NAVIGATION AND VESSEL INSPECTION CIRCULAR NO. 4-85 CHANGE 2

Subj: Change 2 to NVIC 4-85 of 29 May 1985, Recalls and Other Corrective Measures for Lifesaving and Fire Protection Equipment

New Safety Pin for Viking Release Gear in Watercraft America Lifeboats
Coast Guard Approvals 160.033/66/0, 160.033/66/1, and 160.033/66/2

Figure 1 of Enclosure(22) to NVIC 4-85 CH-2

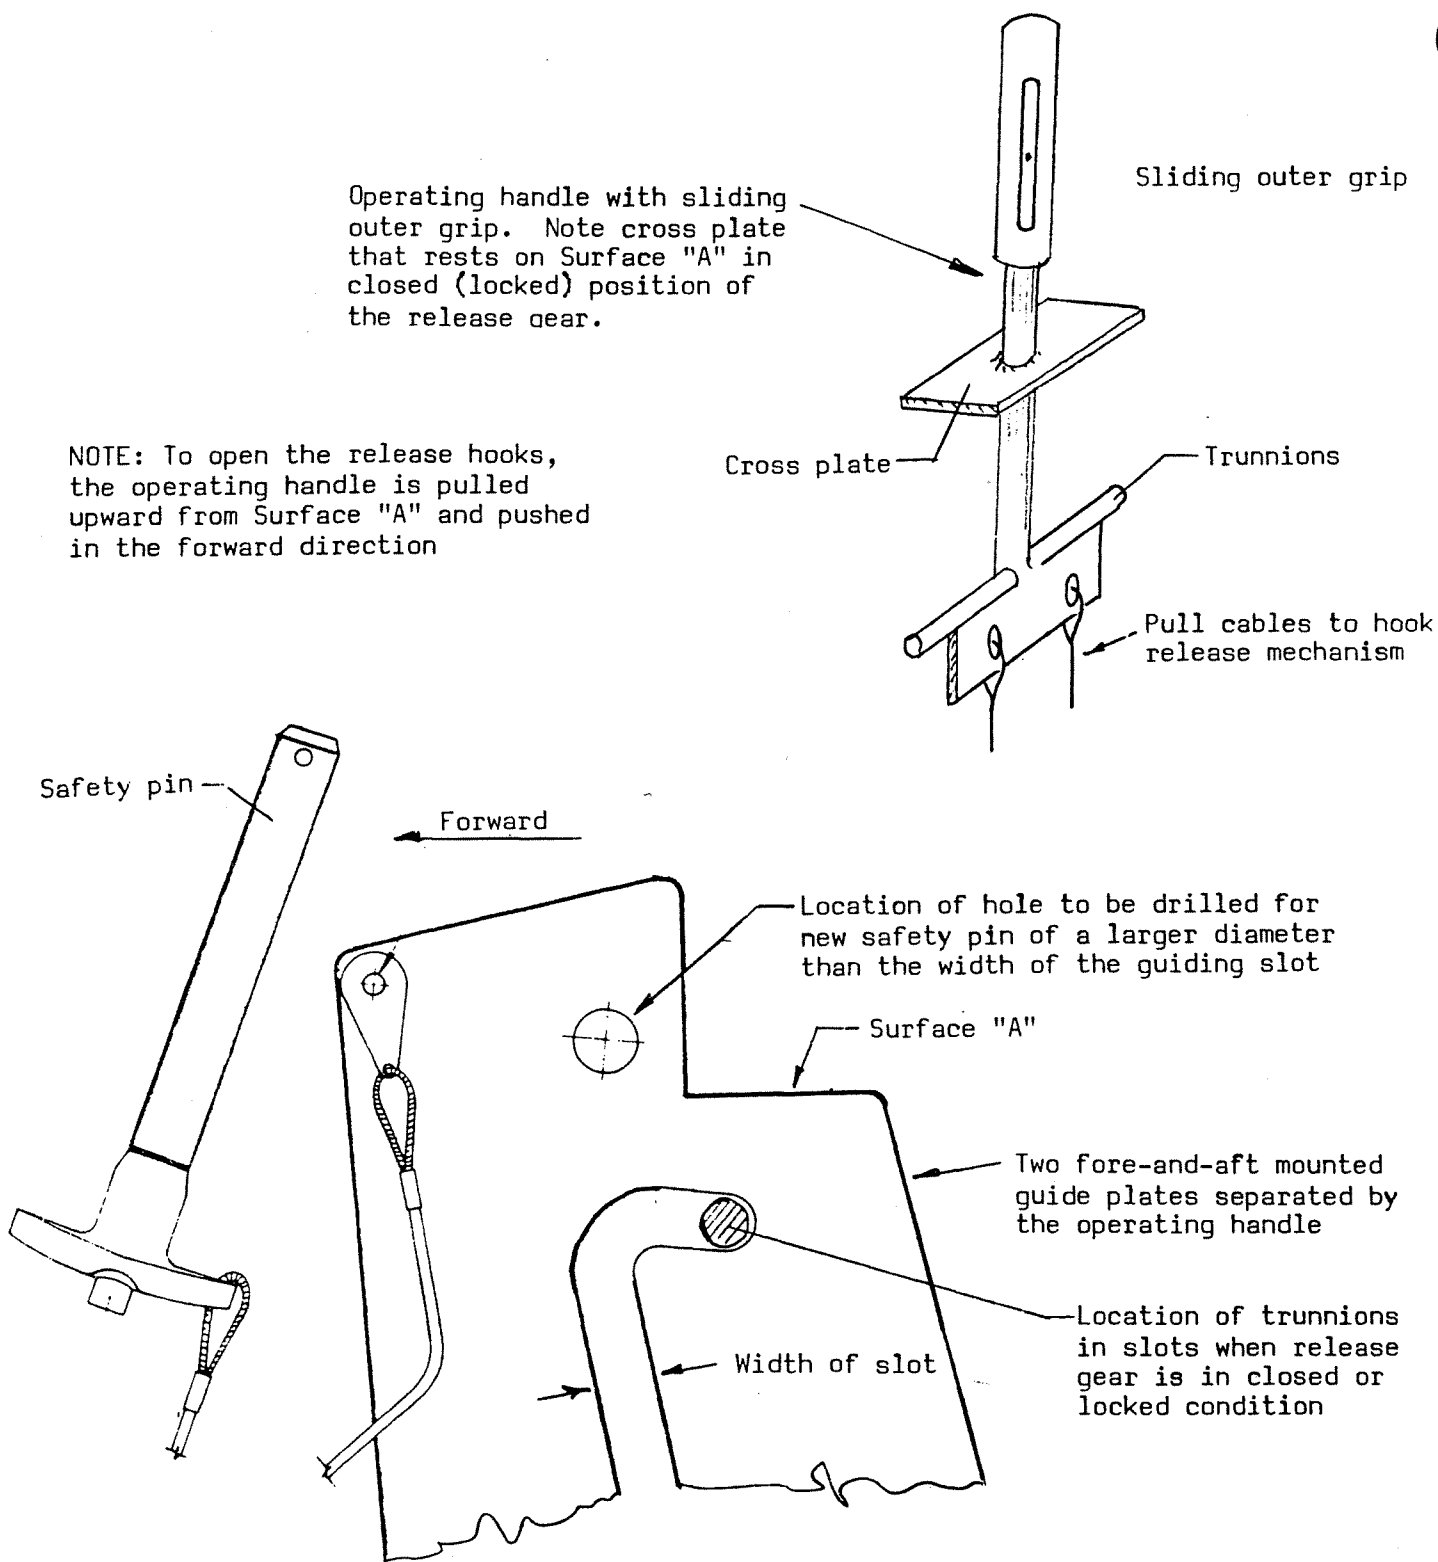
1. PROBLEM. The safety pin for the Viking release gear operating handle used in certain Watercraft America lifeboats, can be accidentally inserted into the slot for the release handle trunnion, rather than the hole intended for the safety pin. If this is done, the release gear is not in a safe condition.

2. DISCUSSION. Watercraft America, Inc. has developed a modification to prevent the accidental insertion of the safety pin before the handle is in the fully closed position. Viking release gear with approval numbers 160.033/66/0, 160.033/66/1, and 160.033/66/2 must be modified by drilling out the safety pin hole and replacing the original safety pin with a larger one.

3. ACTION.
 - a. Vessel and MODU operators having Watercraft America lifeboats equipped with Viking gear having approval numbers 160.033/66/0, 160.033/66/1, or 160.033/66/2 shall make sure the release gear is modified in accordance with Watercraft America drawing SP204 dated May 2, 1986. The Coast Guard Officer in Charge of Marine Inspection shall be notified before the modification work begins. The drawing and instruction may be obtained from:

Watercraft America, Inc.
P.O. Box 1130
Edgewater, FL 32032
(904) 428-5781
Telex: 567415
 - b. Coast Guard inspectors will require modification of Watercraft America Viking release gear with approval numbers 160.033/66/0, 160.033/66/1, or 160.033/66/2 in accordance with the Watercraft America drawing and instruction.

Figure 1 of Enclosure(23) to NVIC 4-85 CH-2

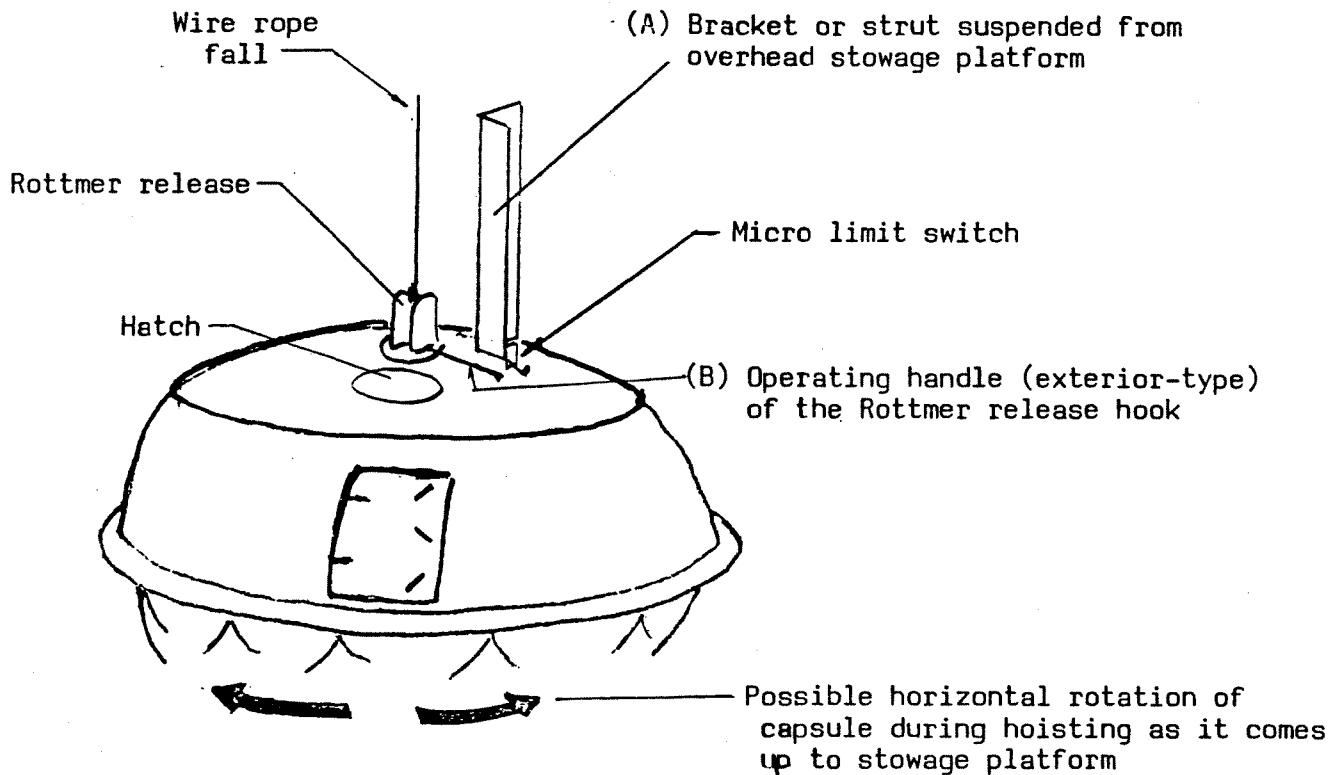
1. PROBLEM: Some launching devices for Whittaker Survival capsules may have been modified by the unauthorized addition of brackets to hold microswitches or other devices added by the owner or operator.

2. DISCUSSION: The unauthorized modifications may appear to be almost identical to the brackets that hold the limit switches which are part of the approved launching system. If brackets are added and not carefully located, they can engage the cable and sector operating mechanism on those capsules equipped with Rottmer type hooks. This has happened on two separate occasions, resulting in the accidental opening of the hook and dropping of the capsule. Any person on board the capsule is at risk of being seriously injured.

NOTE: The above arrangement has the danger of letting the operating handle(B) of the Rottmer release to push against the bracket(A) suspended from under the stowage platform. This could result from the horizontal rotation of the capsule as it comes up into the stowed position. This unintended interference is a potential hazard because of the chance that the operating handle(B) could be moved from its locked position, thus permitting the capsule to drop free of the wire rope fall.

3. ACTION: Servicing personnel and Coast Guard inspectors should make sure that any brackets on Whittaker capsule launching devices are part of the approved system or are approved modifications. Generally, the only brackets coming close to the surface of the capsule should be those holding the limit switches which prevent the capsule from being winched into the stops under motor power. Any others should be considered suspect, unless the owner or operator can show that they are approved additions. Any unauthorized modifications of this type must be removed. Questions on whether or not such brackets are approved can be answered by the manufacturer:
